Subject: Mine Ventilation Plan, Section 75.370, 30 CFR 75, Upper
Big Branch Mine-South, I.D. No. 46-08436, Performance
Coal Company, Montcoal, Raleigh County, West Virginia

Re: Performance Coal Company
Upper Big Branch Mine
MSHA ID : 46-08436
State ID: U-3042-92
Ventilation Revision

PERFORMANCE COAL COMPANY P.O. BOX 69, NAOOMA, WV 25140	
UPPER BIG BRANCH MINE	
M.S.H.A. ID No. 46-06436	WV ID No. U-3042-92
Date: 10-06-08	DWG No. 1 of 1
DRAWN BY: RL 3 Staff	SCALE: 1"=200'
CHECKED BY:	
VENTILATION REVISION	
Mining One Right Crossover	
Phase I

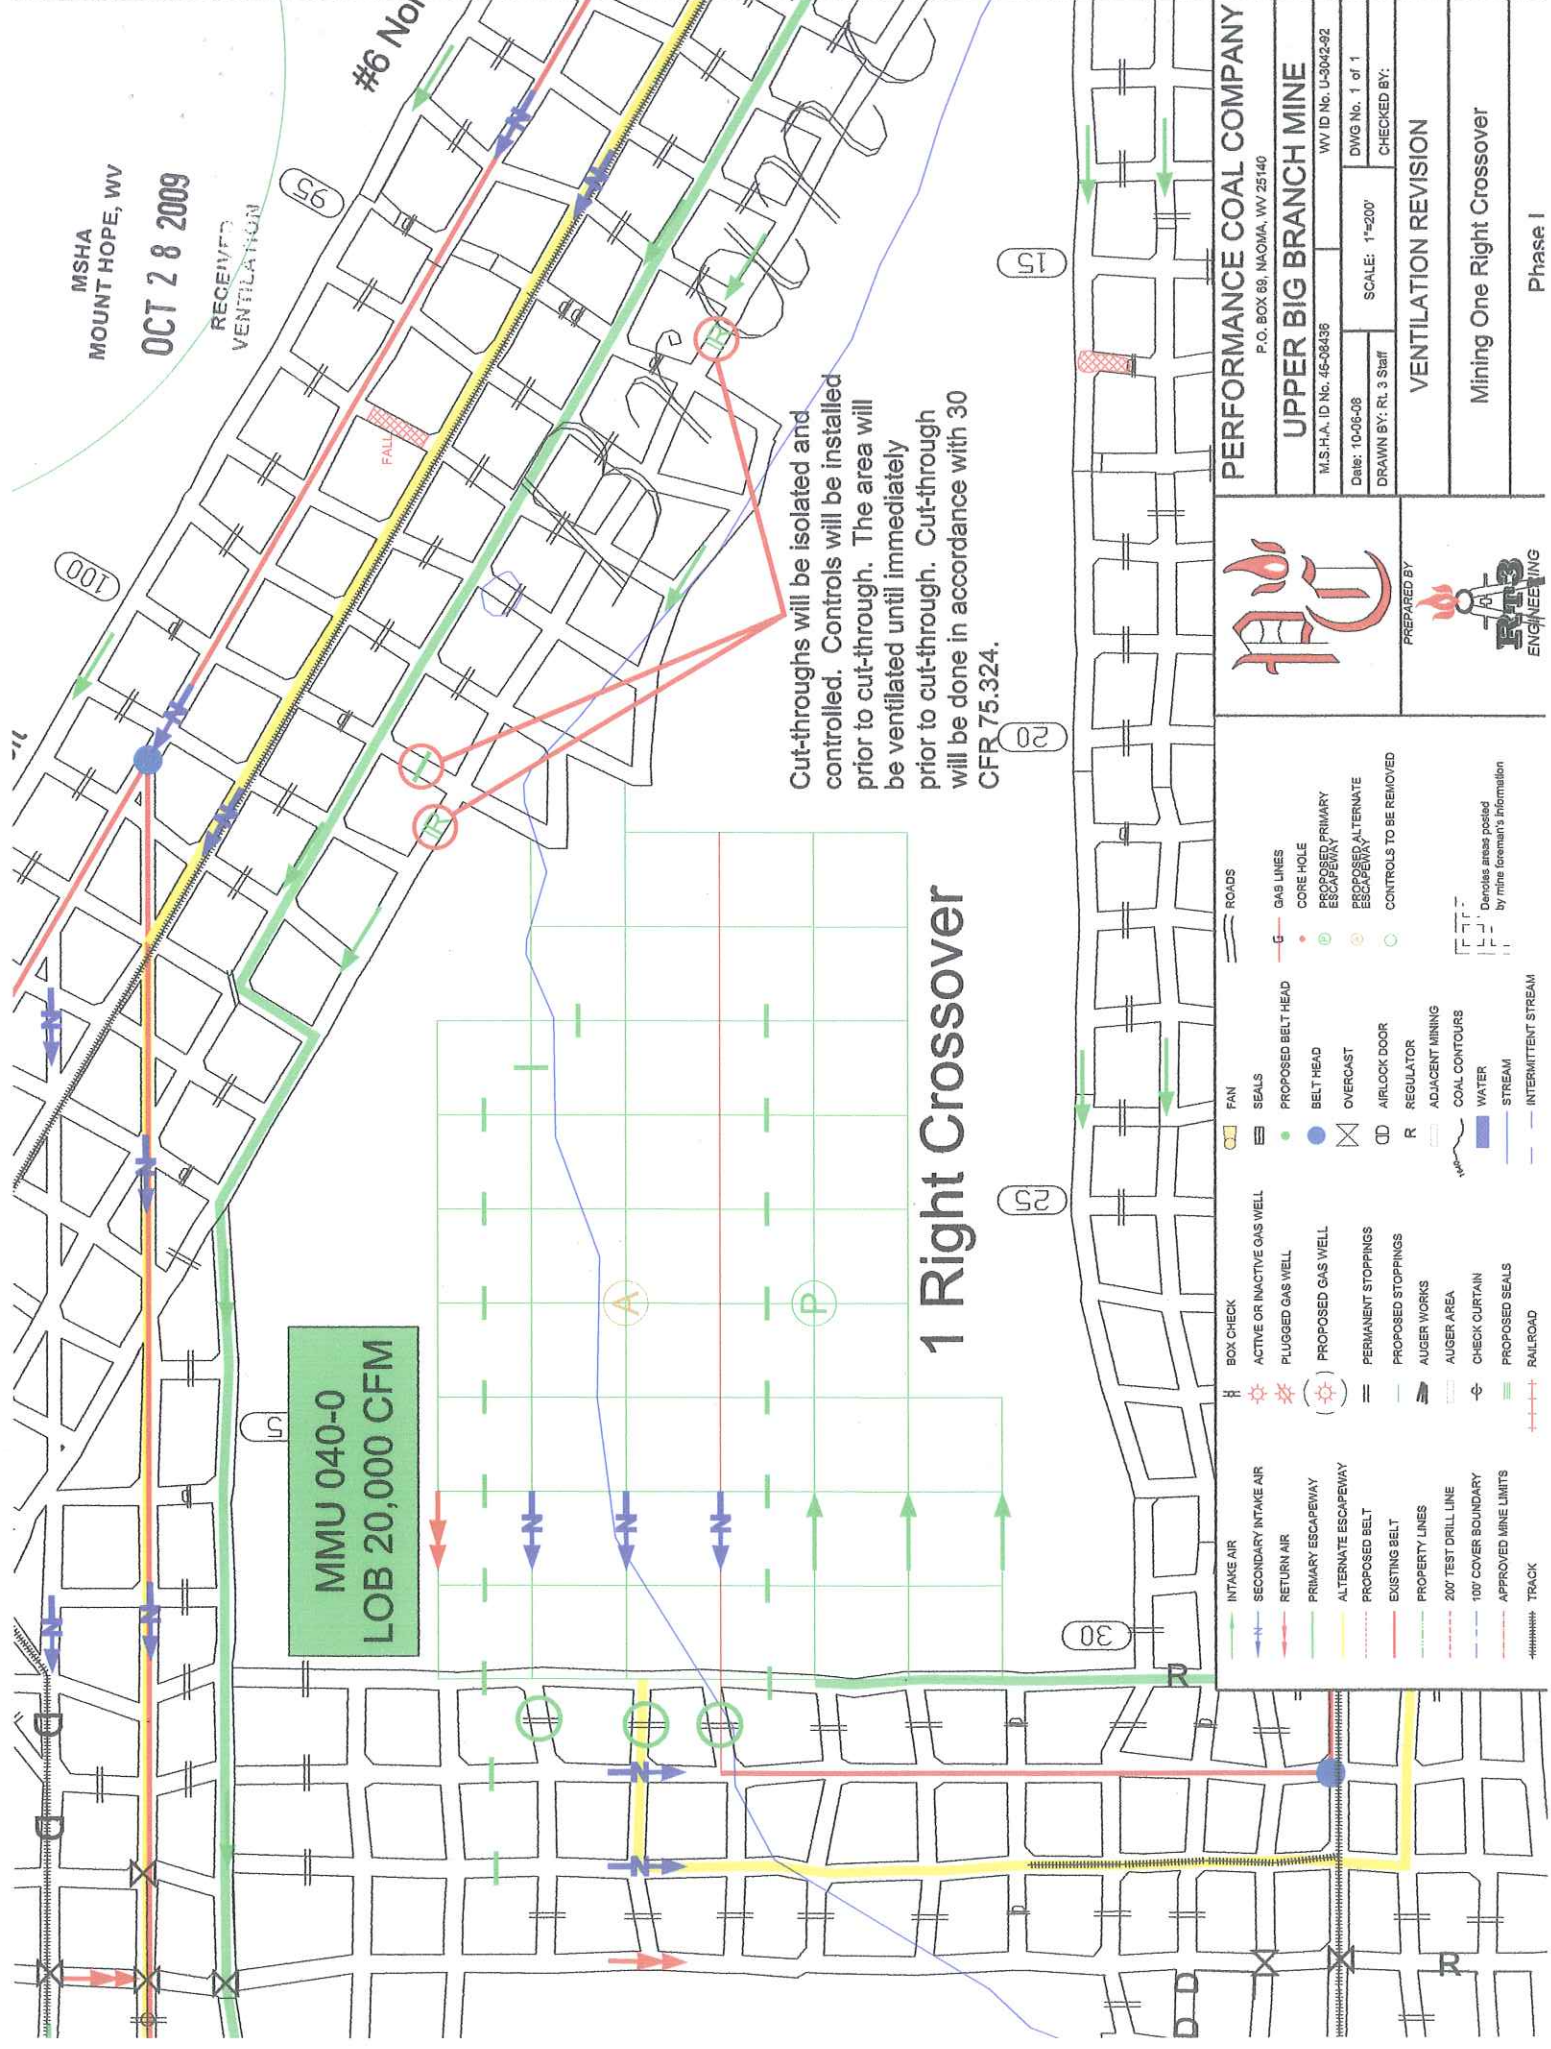
Phase one shows the ventilation while mining and cutting-through. This cut-through will be isolated and controlled. Regulators will be built on the inby and outby sides of the cut-through. These regulators will remain open to ventilate the area until immediately prior to cut-through.

Cut-throughs will be isolated and controlled. Controls will be installed prior to cut-through. The area will be ventilated until immediately prior to cut-through. Cut-through will be done in accordance with 30 CFR 75.324.

The revision is hereby approved and will be made a part of the approved ventilation plan for this mine. This approval is limited to the requested change as described in the submittal letter and shown on the sketch. Please be advised that both phases of the ventilation revision must be done in accordance with 30 CFR 75.324.

Phase II

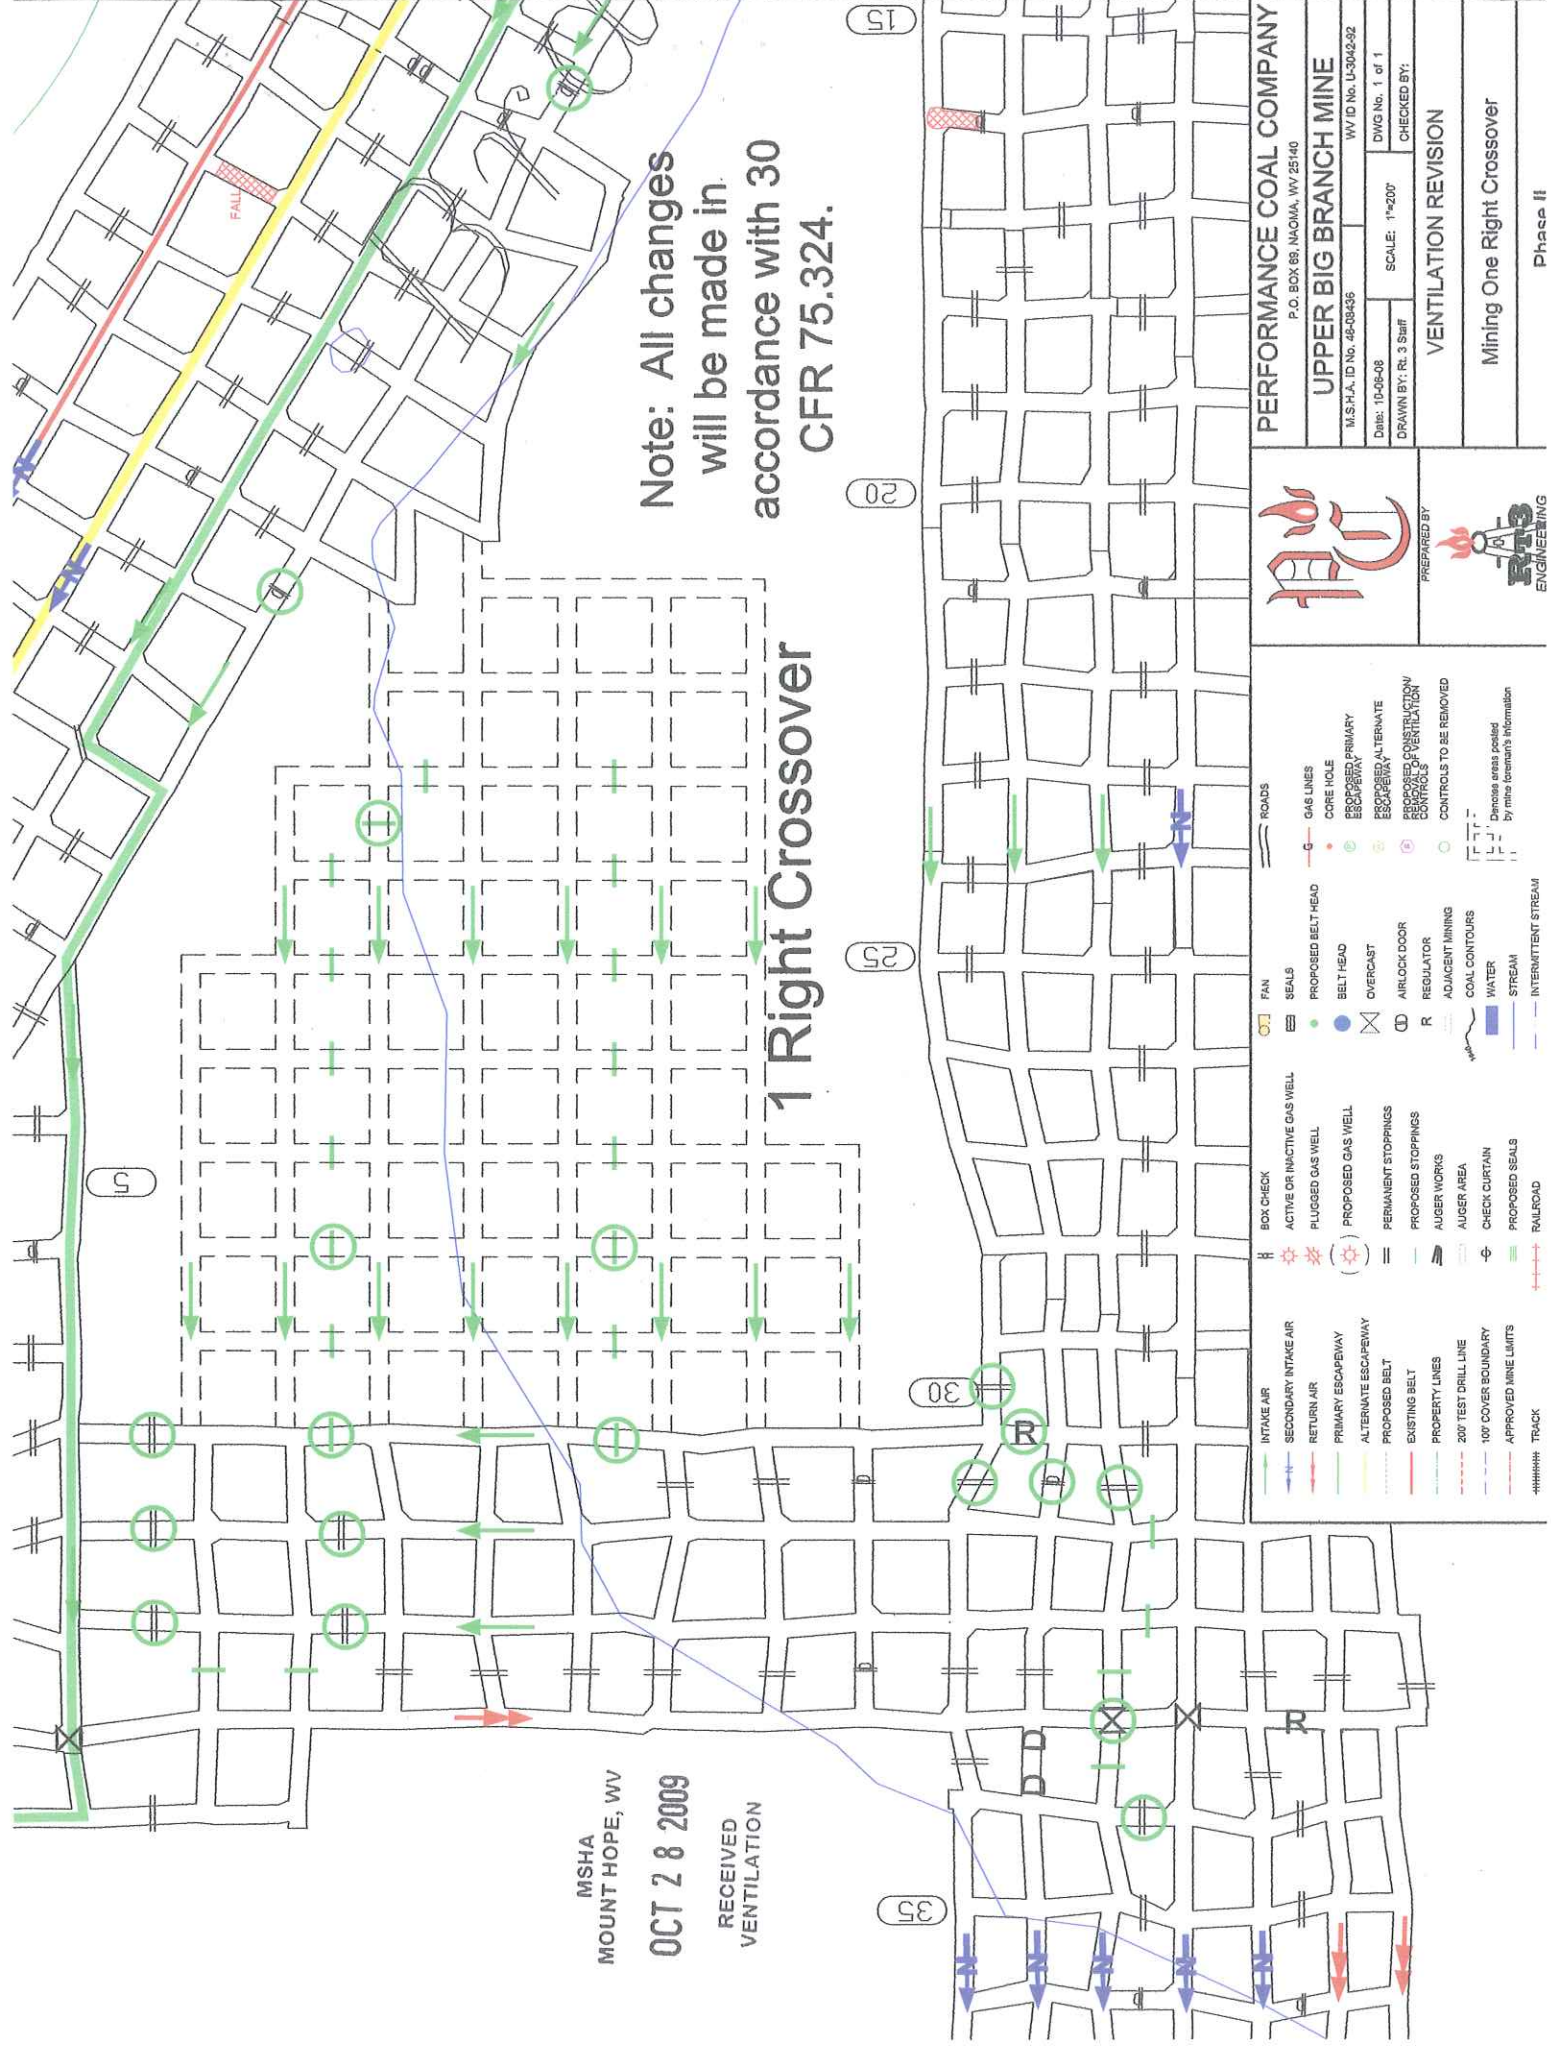
Phase two shows the installation and removal of controls in the 1 Right Crossover to create additional intake once the cut-through is complete and the section moves. Headgate 3 North will be mined under the longwall ventilation revision dated August 6, 2009.

Note: All changes
will be made in
accordance with 30
CFR 75.324.
